Access Compliance Report

Public Rights-of-Way

Intersection ID: 14178	Main Street: E_8TH_ST	Cross Street: RIDGEWAY_AV	Location: S
ADA ID: 1EDDD29EAAE2	Ramp Type: PerpDiag	Initial Pass/Fail: Fail	Overall Compliance: No
Severity Score: 13.75			
Codes/Mitigation Info/Possible Solution		Field Measurements/Component Compliance

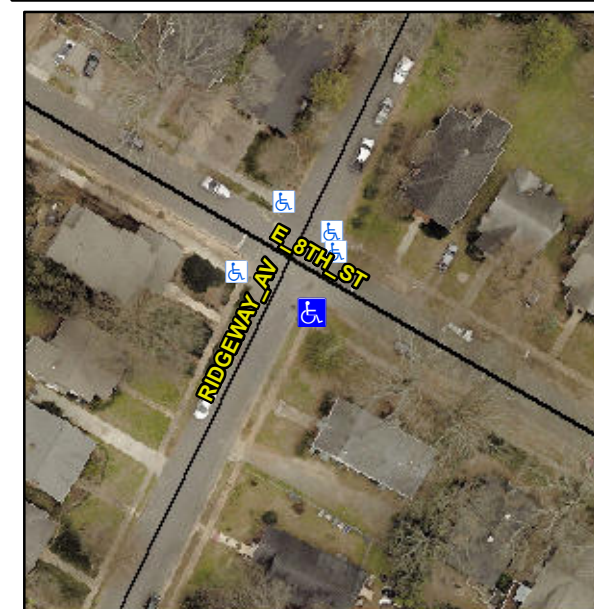
R304.2.2, R304.5.3

Compliance	Description	Data	Compliance	Description	Data
N/A	Ramp Length (in)	56.0	No	Ramp Slope (%)	8.8
Yes	Ramp Width (in)	156.0	No	Ramp XSlope (%)	3.5
N/A	Flare Type LT	N/A	N/A	Flare Type RT	N/A
N/A	Flare Slope LT (%)	N/A	N/A	Flare Slope RT (%)	N/A
N/A	Flare Traversable LT?	N/A	N/A	Flare Traversable RT?	N/A
N/A	Landing Length (in)	N/A	N/A	DWS Provided?	N/A
N/A	Landing Width (in)	N/A	N/A	DWS Contrast?	N/A
N/A	Landing Slope (%)	N/A	N/A	DWS Length (in)	N/A
N/A	Landing X Slope (%)	N/A	N/A	DWS Full Width?	N/A
N/A	Landing Curb? (Y/N)	N/A	N/A	DWS Offset (in)	N/A
N/A	Shared Landing?	N/A			
N/A	Gutter Ponding?	N/A	N/A	Gutter Slope (%)	N/A
N/A	Gutter Lip Ht (in)	N/A	N/A	Gutter X Slope (%)	N/A
N/A	Painted X Walk1?	No	N/A	Painted X Walk2?	No
	X Walk 1 Direction	To NE		X Walk 2 Direction	To NW
N/A	X Walk 1 Width (in)	N/A	N/A	X Walk 2 Width (in)	N/A
	X Walk 1 Slope (%)	2.7		X Walk 2 Slope (%)	1.6
	X Walk 1 X Slope (%)	1.5		X Walk 2 X Slope (%)	4.9

Remove & Replace Curb Ramp With Two New Directional Ramps or Equivalent.
